**S12A AMENDMENT OF PLAN APPLICATION  
APPROVED NGAU TAM MEI  
OUTLINE ZONING PLAN NO. S/YL-NTM/12**

**PROPOSED REZONING FROM "R(C)" TO "G/IC"  
FOR A PROPOSED "SOCIAL WELFARE FACILITIES"  
(RESIDENTIAL CARE HOMES FOR THE ELDERLY)  
(RCHE)**

**AT LOT 4823 IN D.D.104, 81 SAN TAM ROAD,  
SAN TIN, N.T.**

**FURTHER INFORMATION  
OCT 2022**

LG/F PLAN  
 DISCHARGE ROUTE OF THE STP

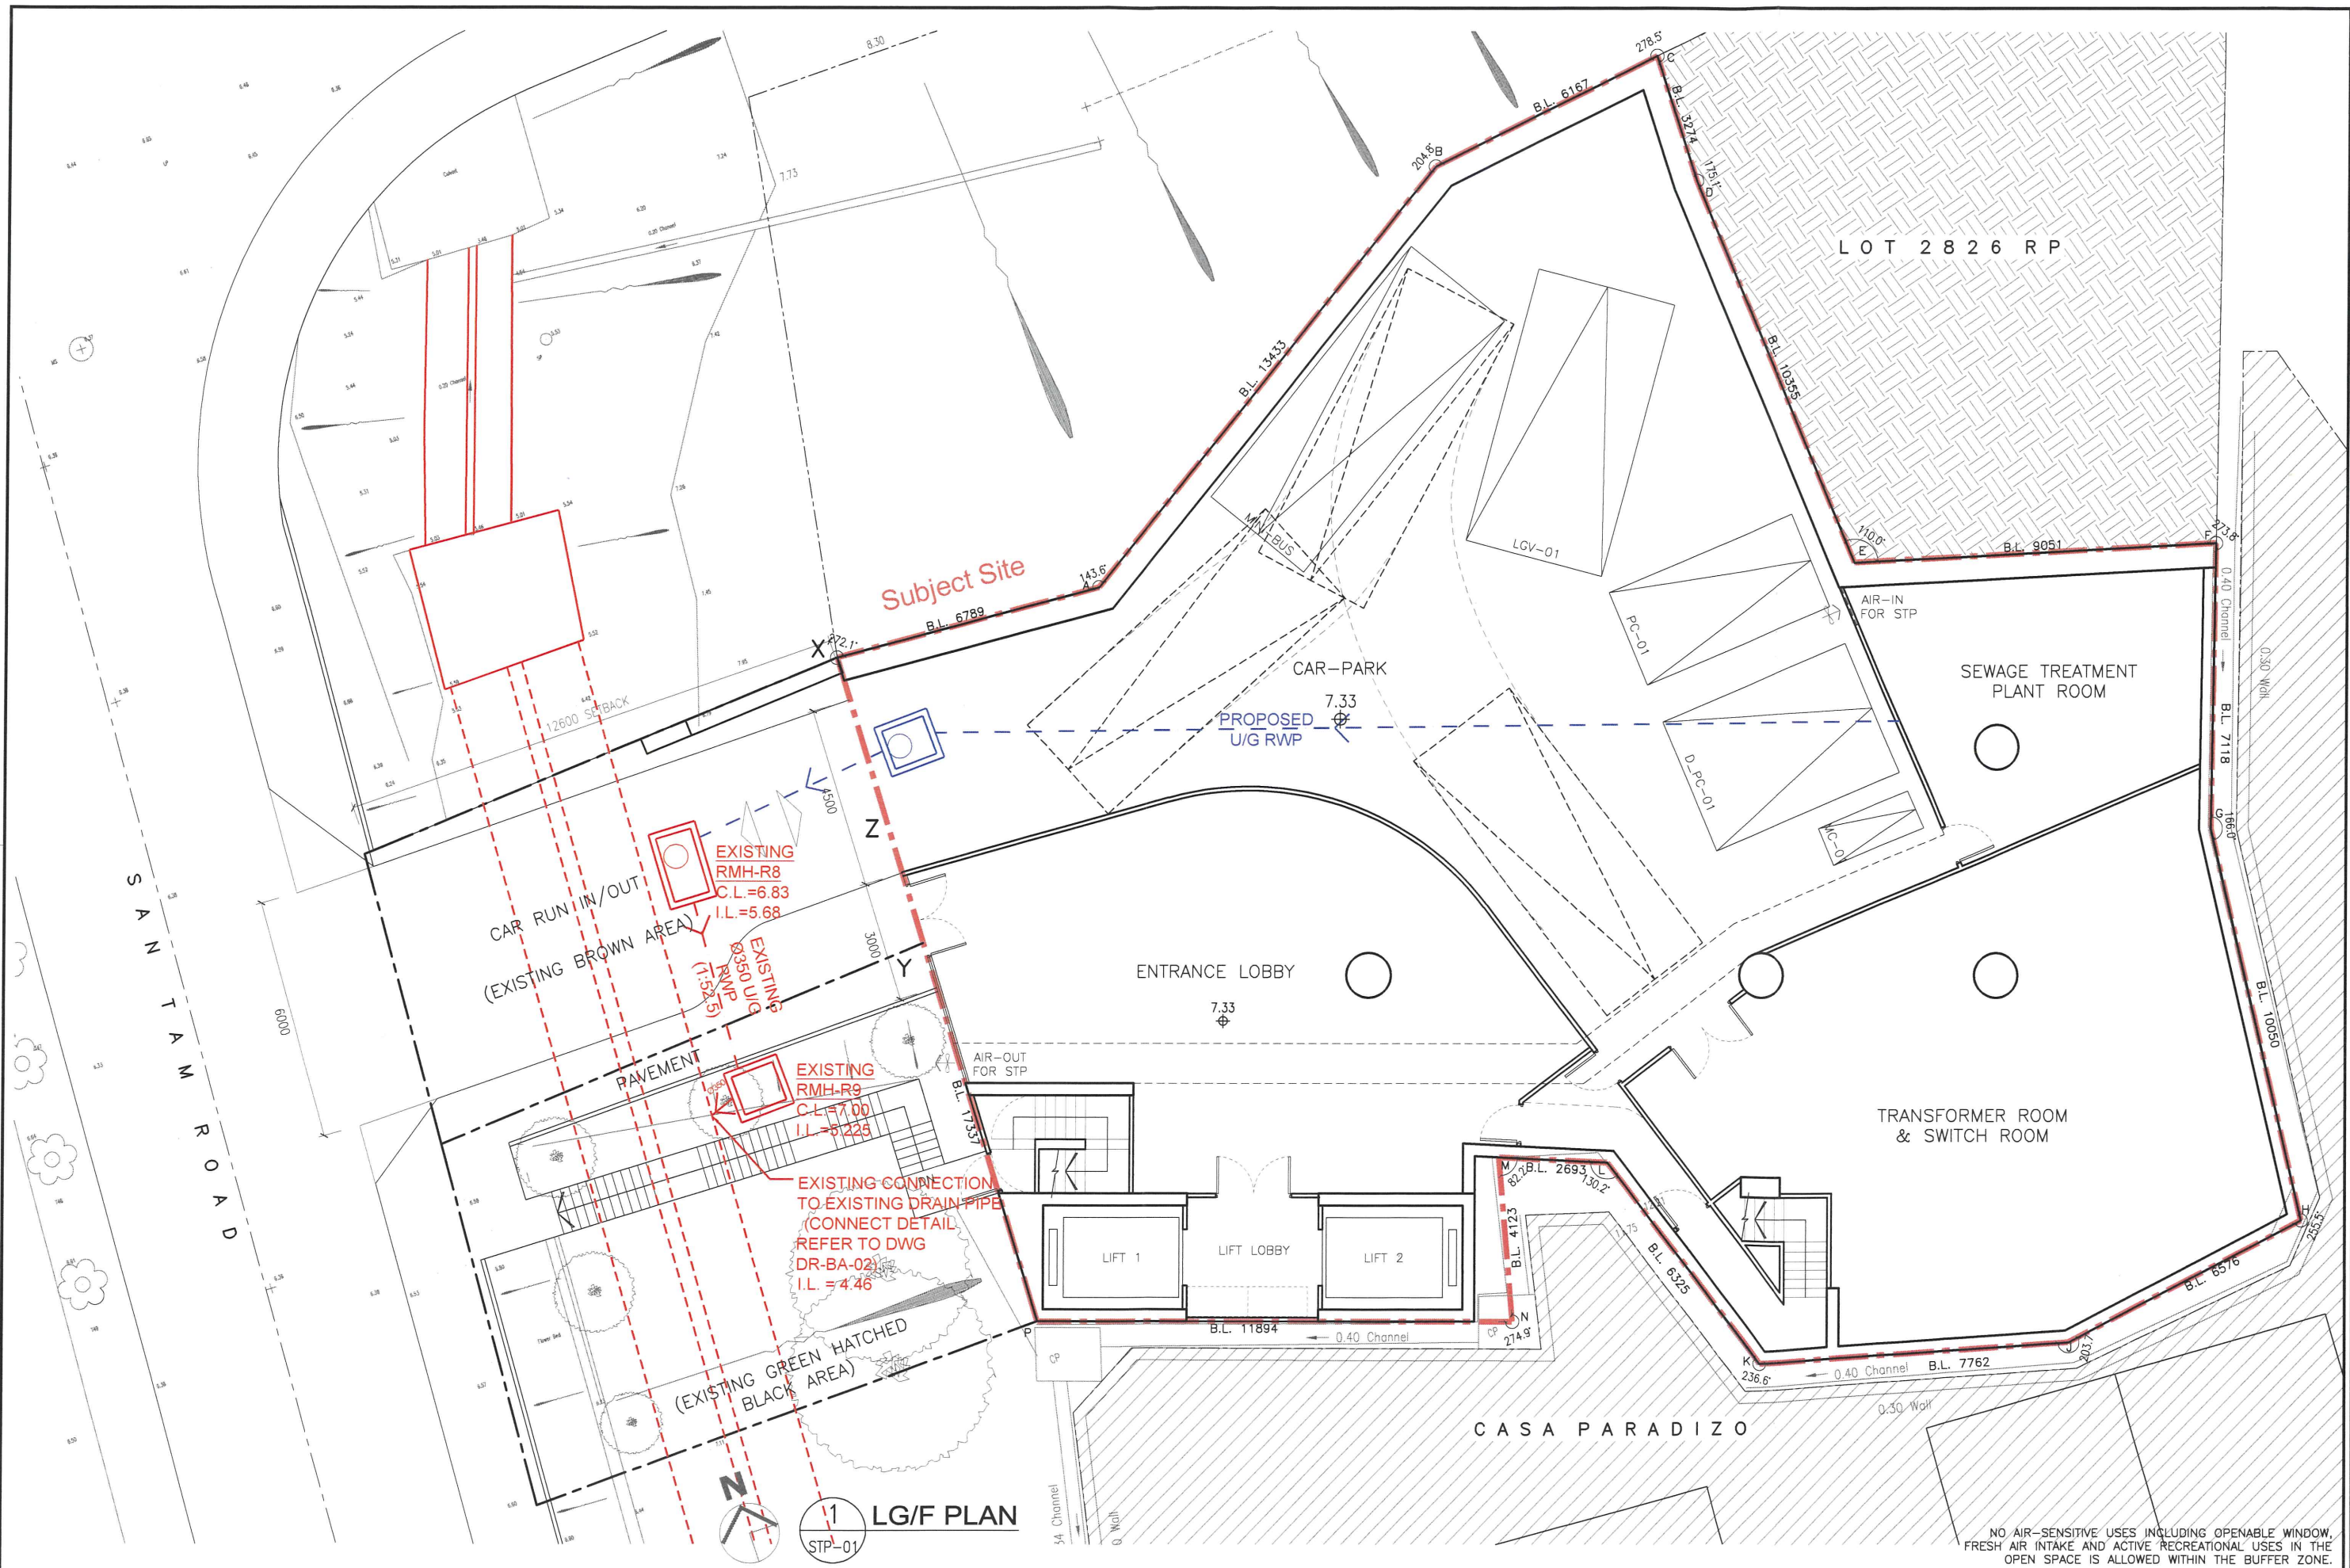
Please list and provide a figure to identify the WSRs within 500m area. Please also indicates the discharge route of the proposed STP. Please also elaborate whether WSRs within 500m would be affected by the proposed development during construction and operation phase.

Representative Water Sensitive Receivers (WSRs) identified within 500m of the Project boundary that may potentially be affected are shown in Figure below.

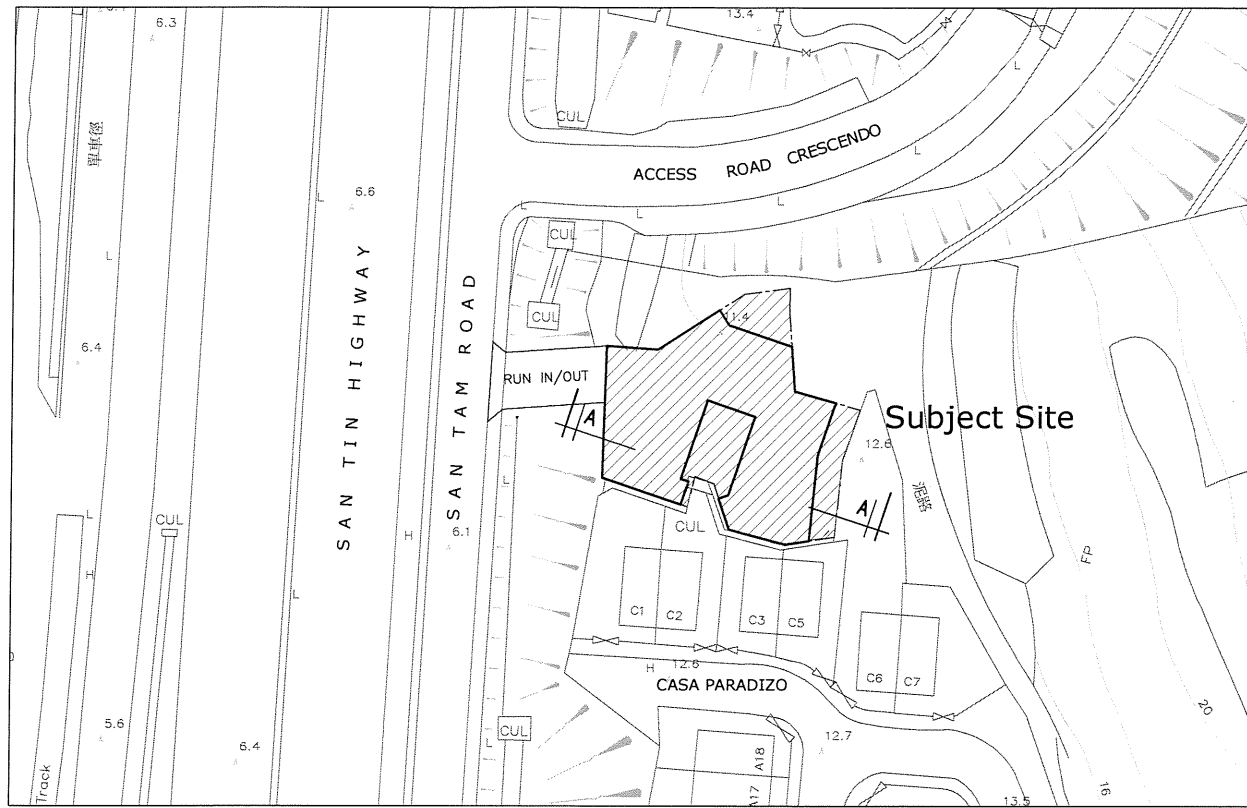
Comments	Response
(x) Figure 14 “Green Coverage Calculation” <ul style="list-style-type: none"> <li>● The provision of greenery coverage has not been indicated on this figure.</li> </ul>	Revised as per Figure 14 Rev. B.

**UG/F PLAN**  
**MULTI-PURPOSE ROOMS**

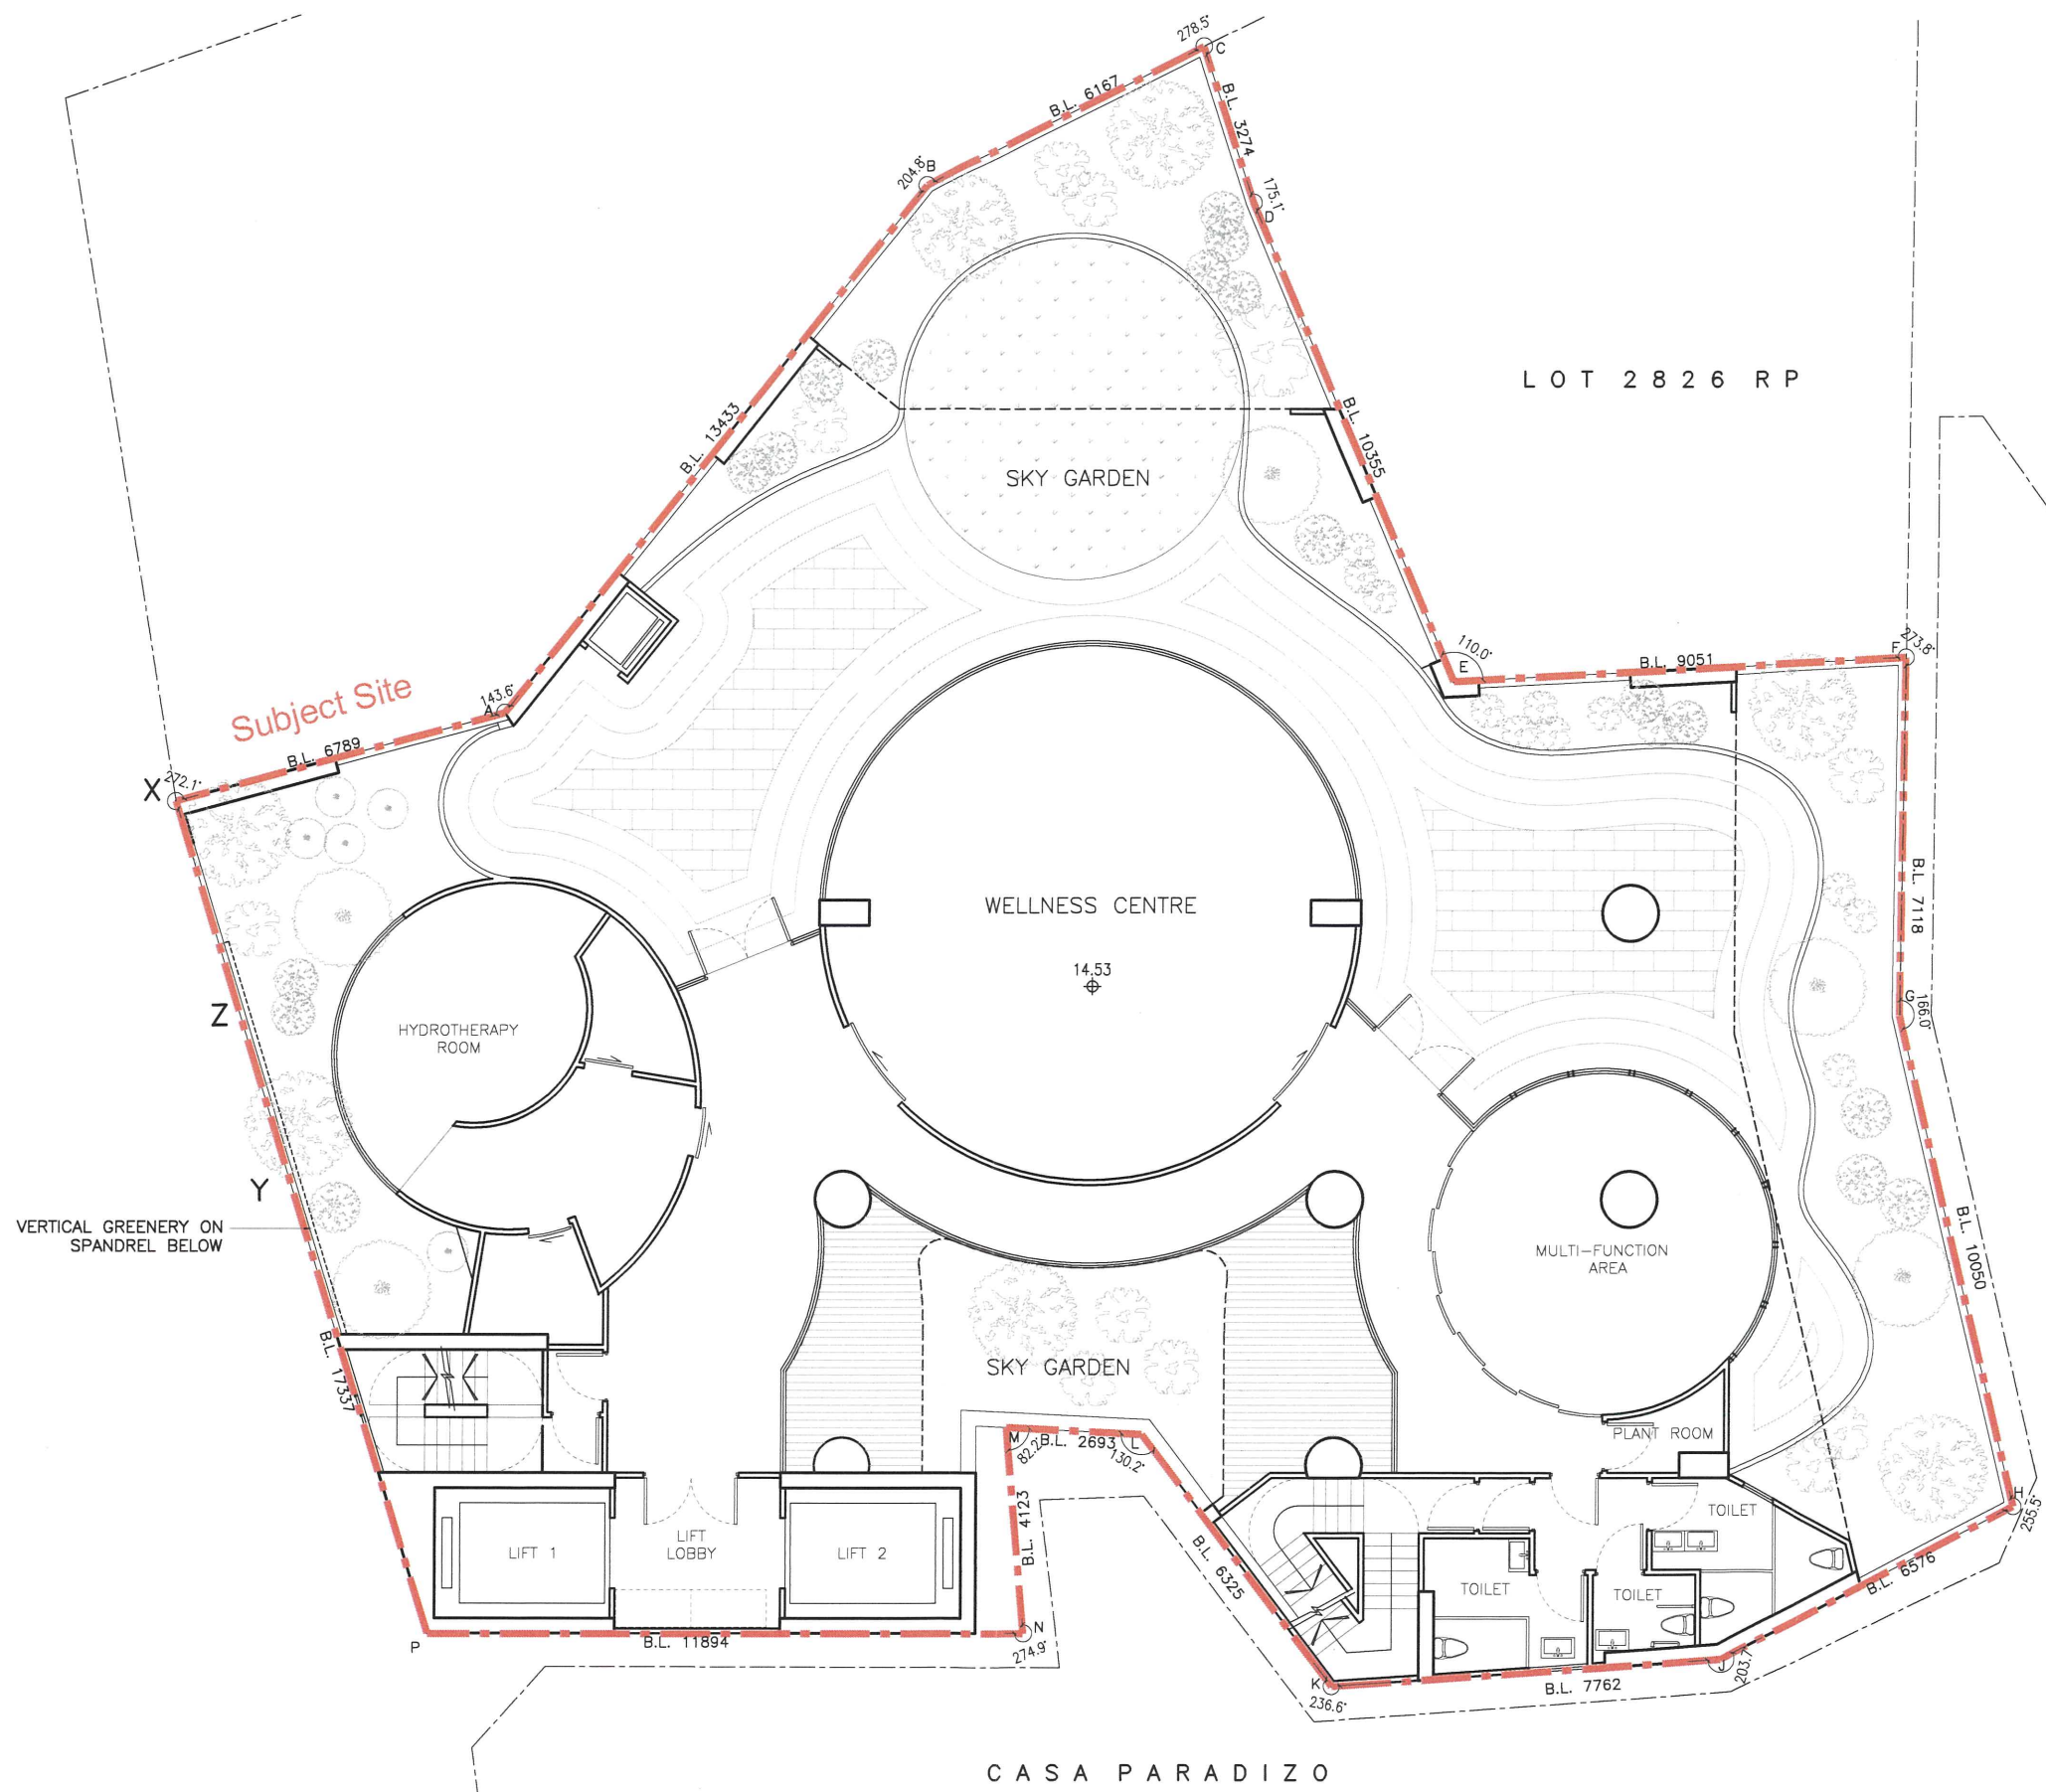
Comments	Response
<p>7. Air quality impact from the proposed kitchen of the proposed development: Please address if there are any oily fumes from the proposed kitchen and any mitigation measures will be in place to alleviate the potential air quality impact on the nearby ASRs in the report.</p> <p>8. Figure 2.1.1: Please provide a remark in the figure to state clearly that no air-sensitive uses including openable window, fresh air intake and active recreational uses in the open space is allowed within the buffer zone.</p>	<p>A grease filter would be applied to remove oily fume. The Catalogue is attached for your information. Routing is shown on the revised G-03 Rev.B.</p> <p>Await reply from our Environmental Consultant.</p>
